Two module electrical output
settings means four spec
conditions, C2M eye mask

Piers Dawe

Nvidia

February 2021

Comment 146, there should be 4 EH-VEC limit pairs

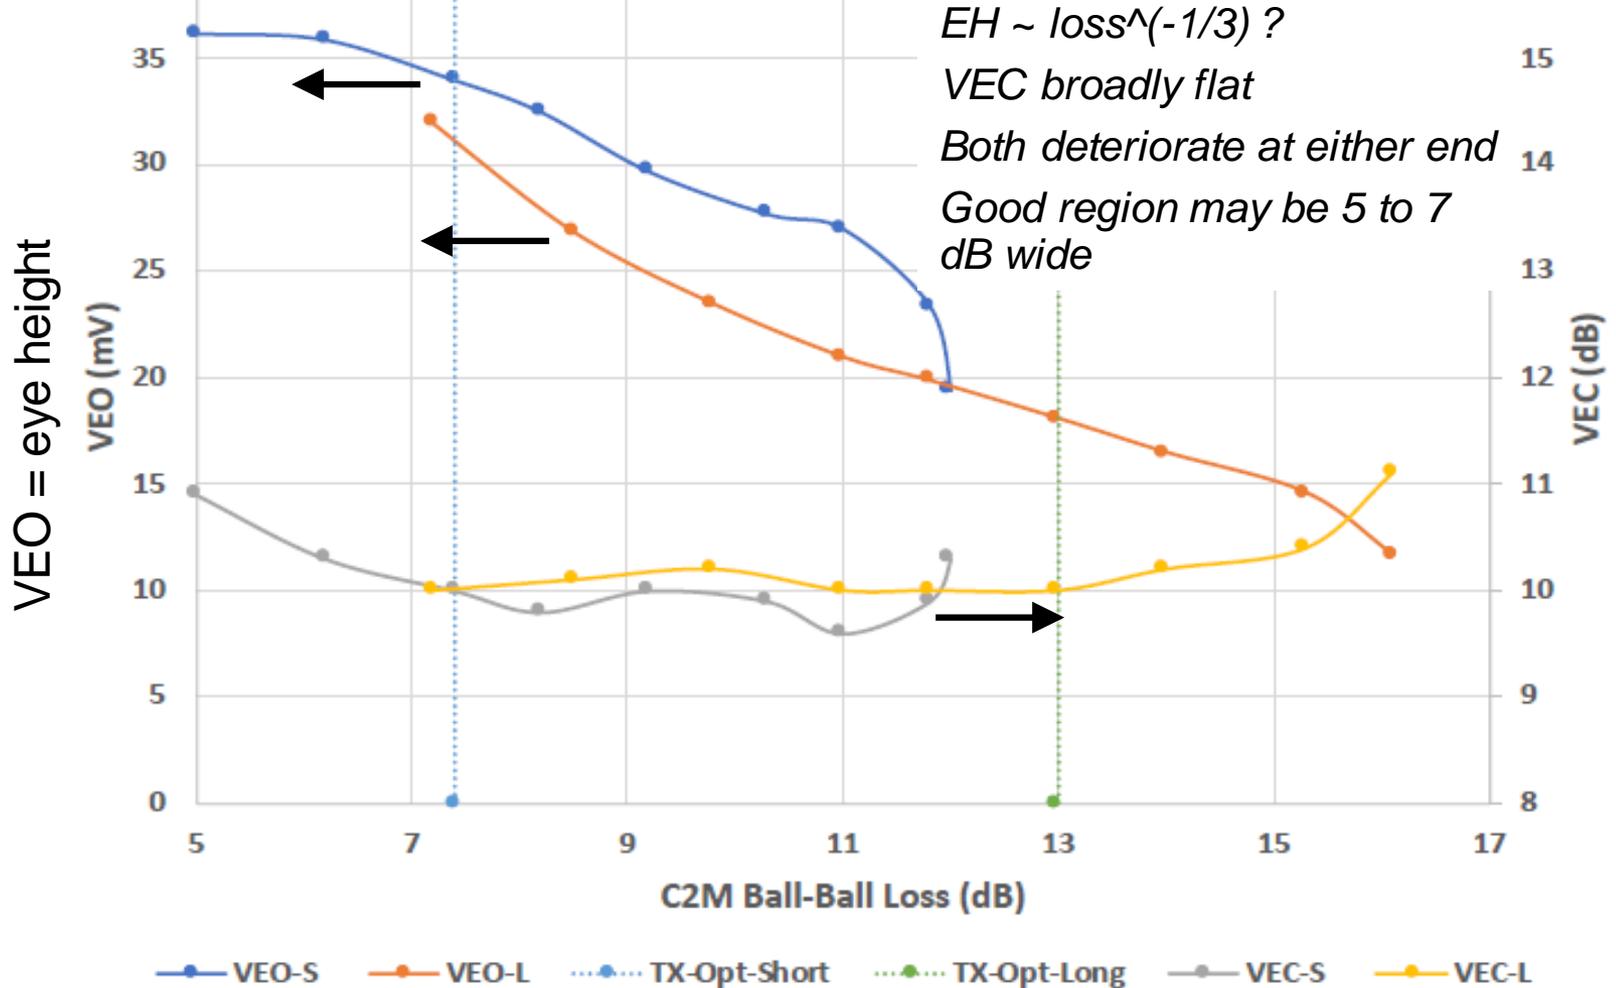
- **CI 120G SC 120G.3.2 P 234 L 14 # 146 TR**
- As already discussed, the 2-settings method with only two compliance losses doesn't work. If the module is set to the short setting, and the host receiver isn't that near, the eye it is offered is smaller than 24 mV because of loss, and out of tune as well. If the module is set to the long setting and the host isn't that long, the eye is also out of tune. There's no guarantee that either setting is usable.
- *Suggested Remedy*
- There should be 4 EH-VEC limit pairs: short near and far, and long near and far, in Table 120G. In 120G.3.2.2.1, give the four zp values: for short, 0 (as at present) and 184, for long, 61 and 244.7 (as at present).

If setting up to the draft spec

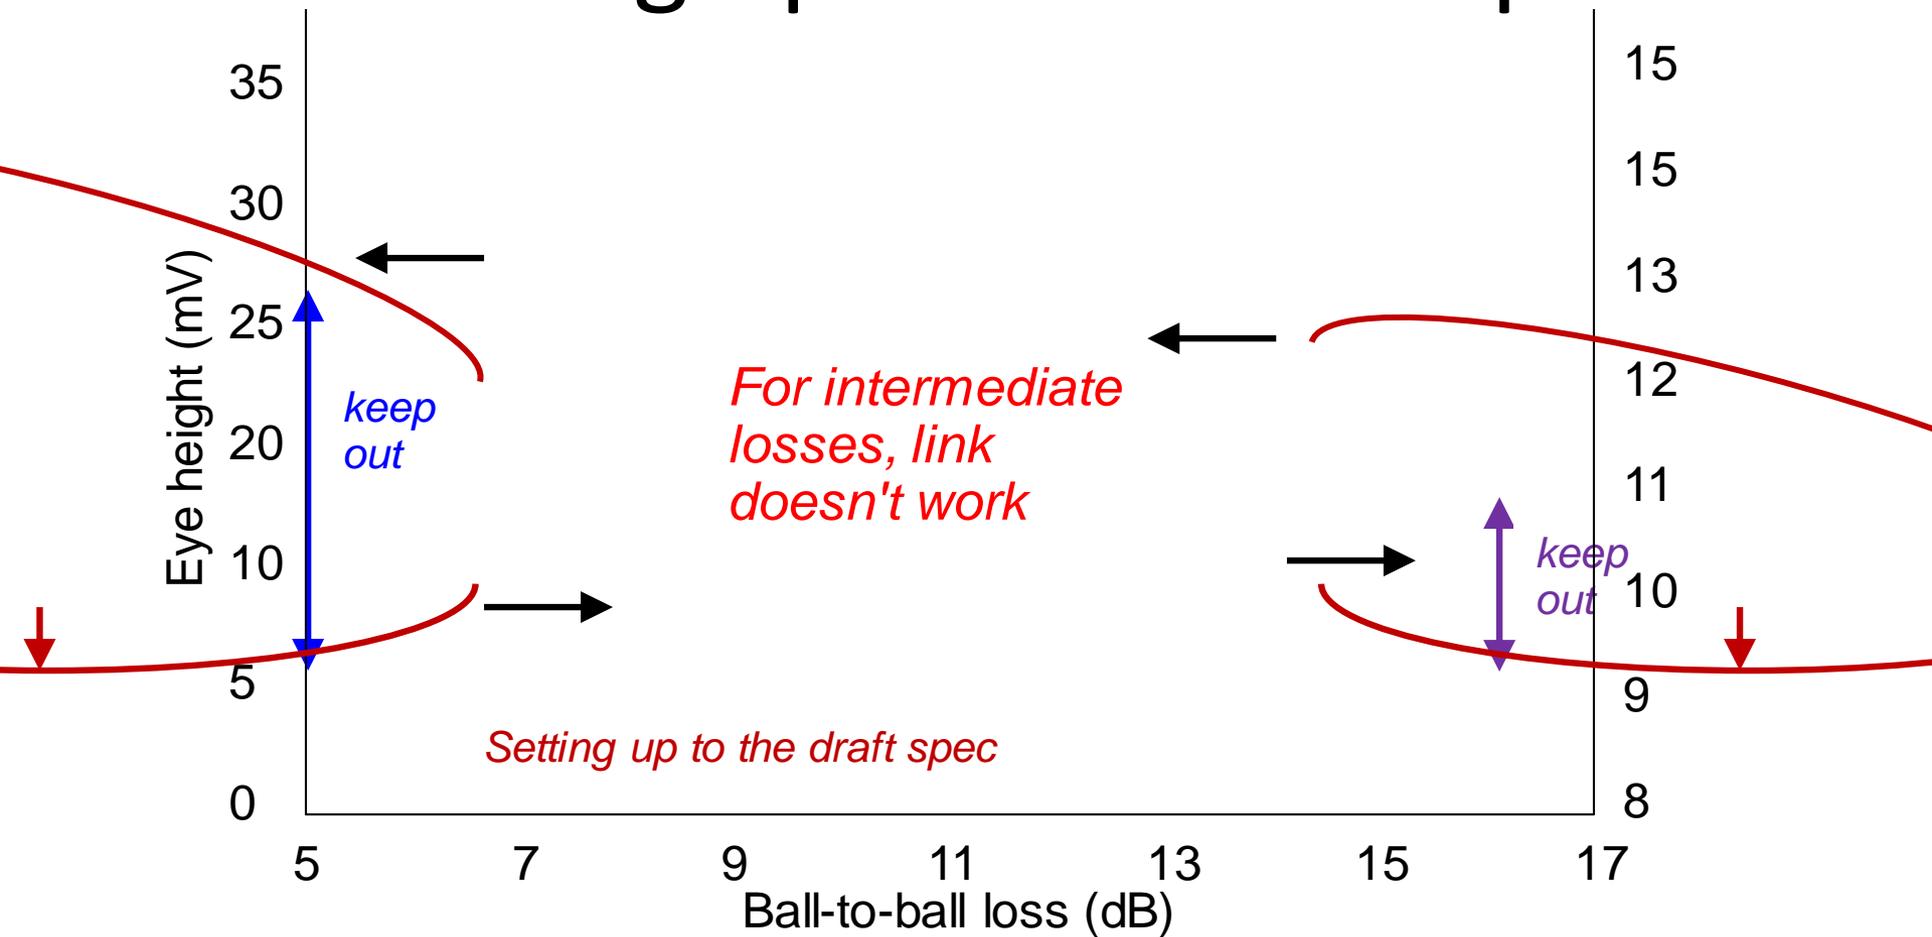
- This setup is has more margin to spec than previous one, but is useless

EH and VEC specs done properly

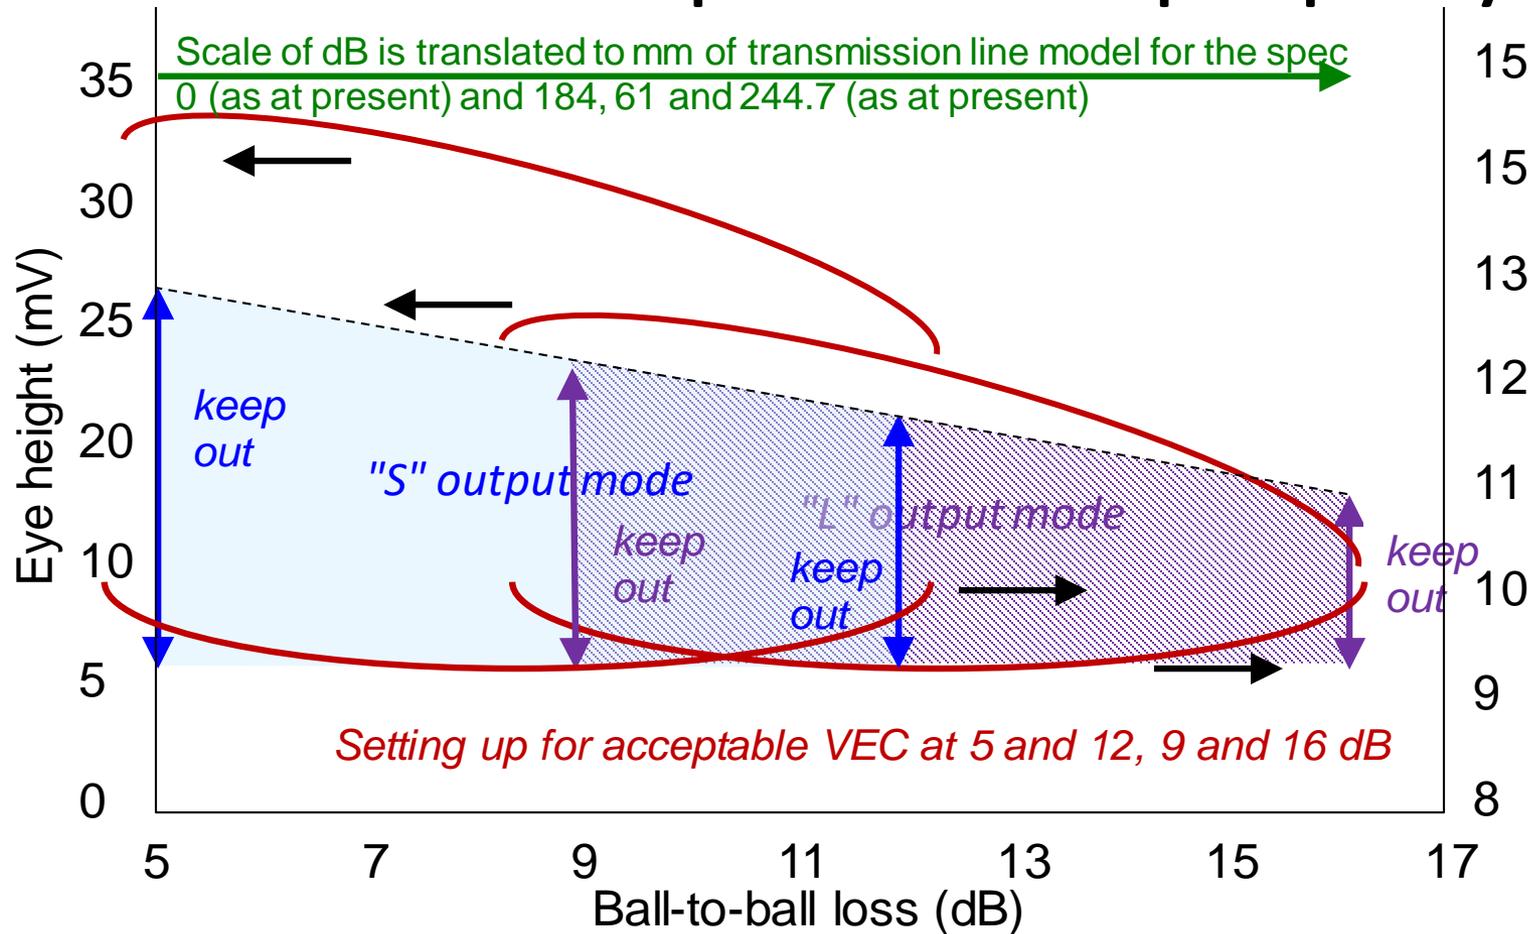
- 4 corners each for S and L ensure usable regions between (shaded, stripes)

EH and VEC specs done properly

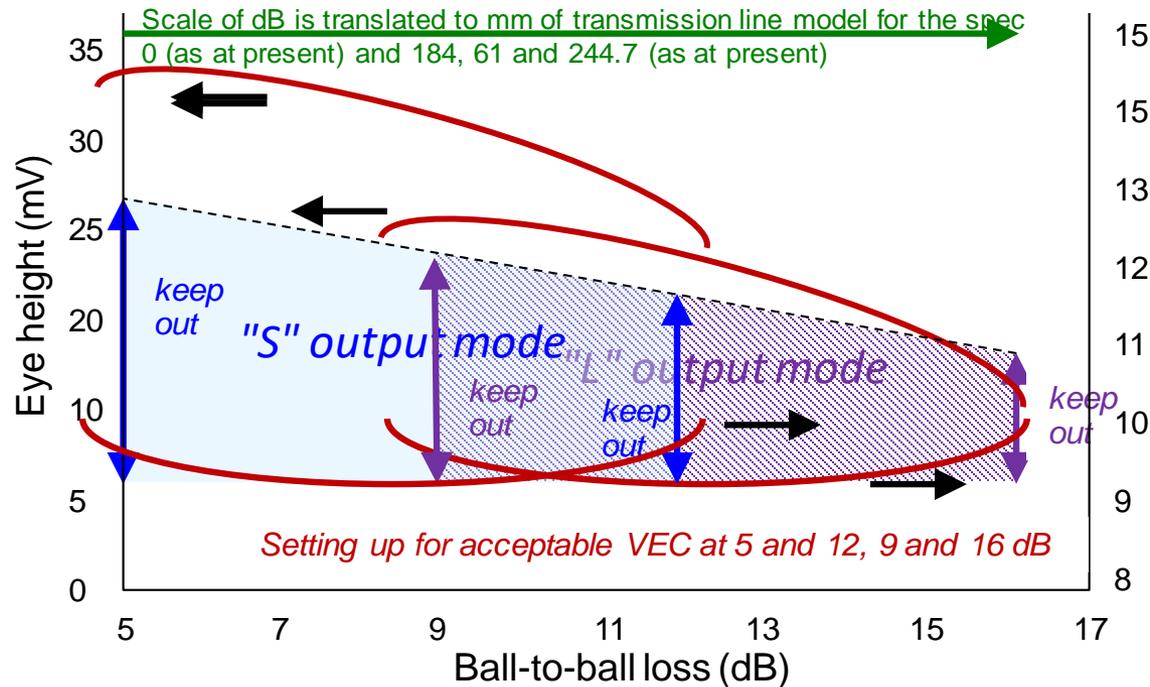
- Host does not know its loss exactly
 - It's not a normative part of the spec anyway
- Different receivers have different abilities at the extremes of signal shape
 - Remember, the receiver can't tweak it as in backplane
- Need a generous overlap between S and L

Comment 154, better C2M eye mask

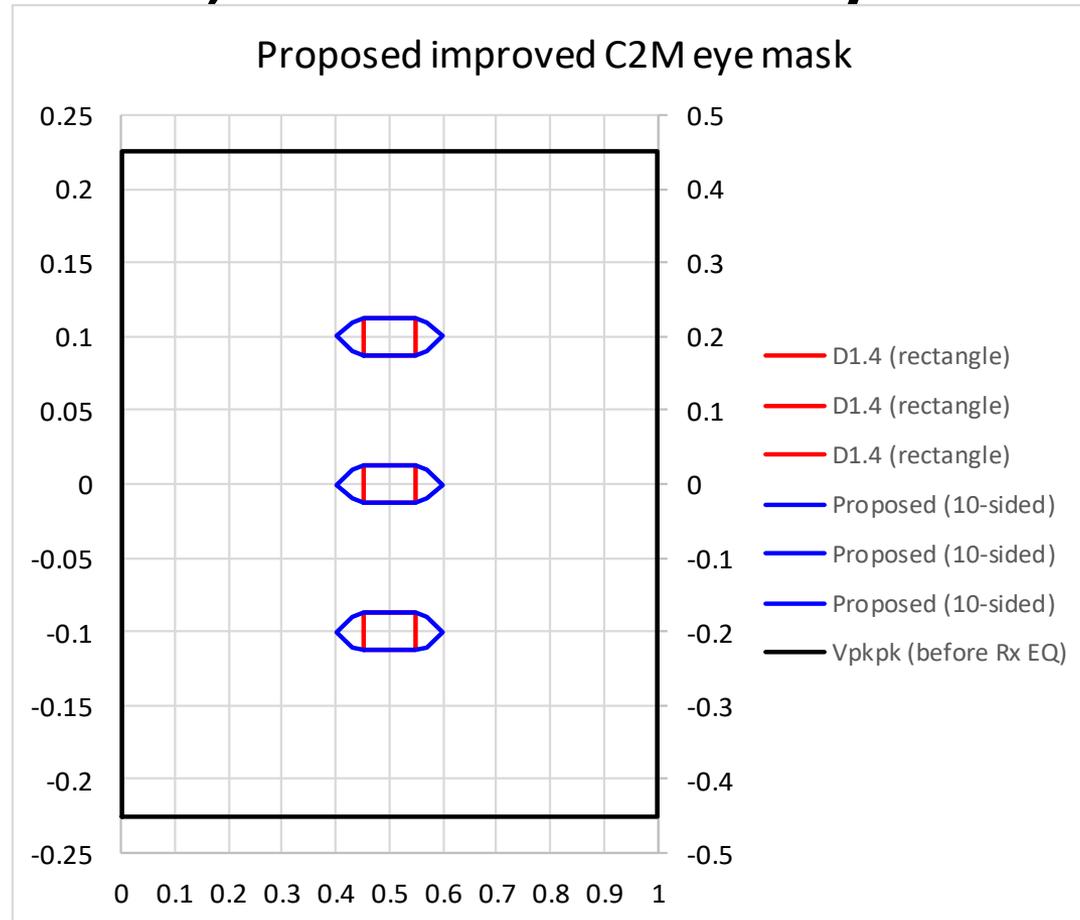
- **CI 120G SC 120G.5.2 P 246 L 23 # 154 TR**
- Of all the options in daw_3ck_01a_1020, this draft has the most primitive (rectangular eye mask) although it is described as a histogram. It's an inefficient/inaccurate way of measuring a signal and provides weak and uncertain protection against too much jitter.

- This will get worse if we relax the VEC limits, and is a particular concern for very short host channels (see Mike Dudek's work).
- *SuggestedRemedy*
- Change from a 4-cornered mask with corners at $t = t_s \pm 0.05$, $V = \pm H_{min}/2$ to a 10-cornered mask with corners at $t = t_s \pm 0.05$, $t_s \pm 0.07$, $t_s \pm 0.1$, $V = \pm H_{min}/2$, $\pm H_{min} * 0.4$, ± 0 .

- (In case it's not clear, H_{min} , already specified, is the greater of EH and Eye Amplitude - VEC. There will be discussion about changing those limits from other comments, but this is a simple scalable method that can remain as the EH and VEC limits are revised.)
